# Transpower's Ōtāhuhu-Whakamaru A and B line reconductoring listed project application

Draft decision - reasons paper

30 April 2026

**Figure A1 OTA-WKM A and B line route sections**

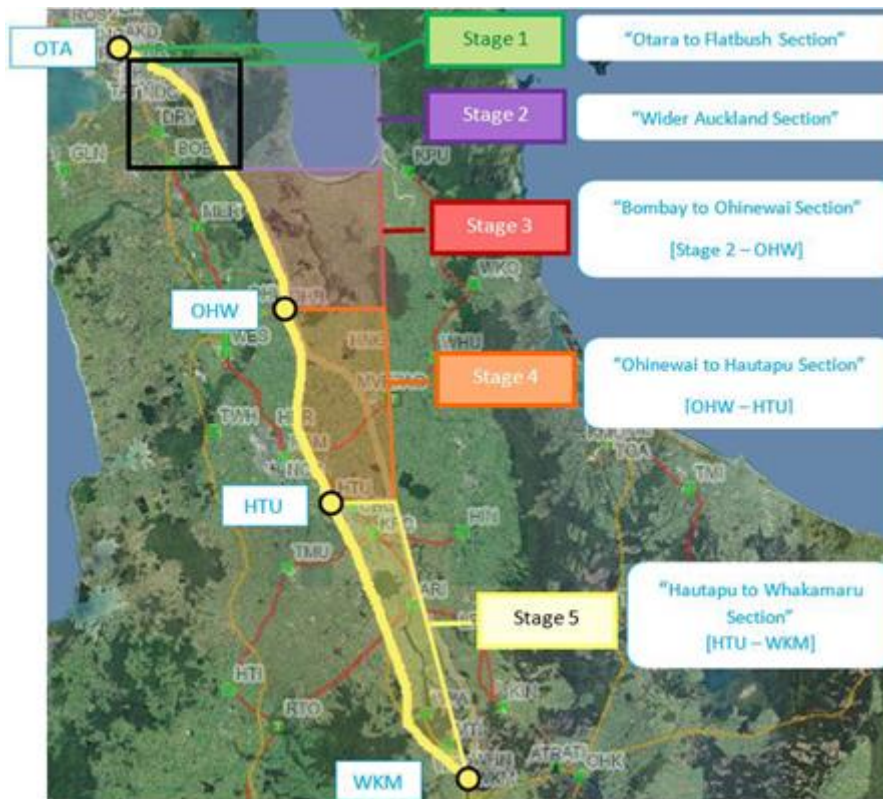
- A1 Transpower is proposing to “replace the existing Goat conductor on the wider Auckland region section of the Ōtāhuhu–Whakamaru A and B lines (OTA-WKM A&B lines), being the section from Flatbush to Hūnua shown as “stage 2”<sup>18</sup>, shown in Figure A1.

- C49 To facilitate a realistic cost-benefit analysis, Transpower included costs to reductor the southern section of the OTA-WKM A and B lines (Stages 3-5 in Figure A1) as the capital costs of modelled projects.
- C50 In what Transpower has termed the counterfactual, the stage 3 reductoring (north of Ōhinewai) is decommissioned, resulting in 39 km less future reductoring than is needed. This use of a counterfactual is discussed later in this attachment.
- C51 Following our review, we consider that Transpower has carried out a robust process to estimate its capital costs. The proposed investment capital cost has been based on an SSR, and alternative option costs have leveraged off the accuracy of the SSR. We agree with Transpower's approach.

**Figure C2 Upper North Island transmission network<sup>69,70</sup>**

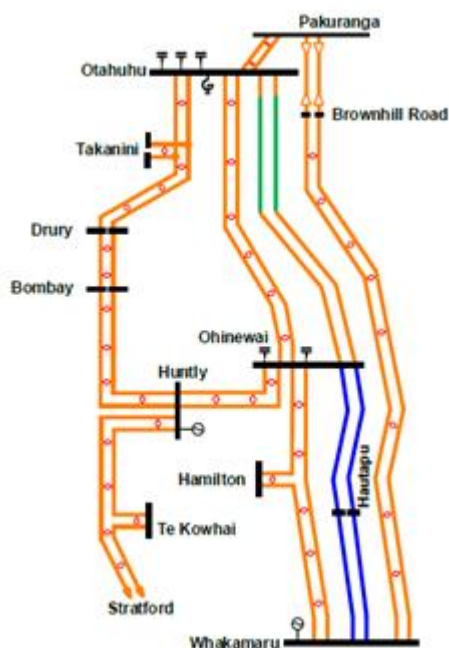
C91 Transpower that this like for like reconductoring cost makes “duplexing the southern section of the OTA-WKM A&B lines and bussing into Ōhinewai substation (see Figure C2) another likely option for the WUNI2 project” which is likely to be submitted to the Commission during 2026.<sup>68</sup>
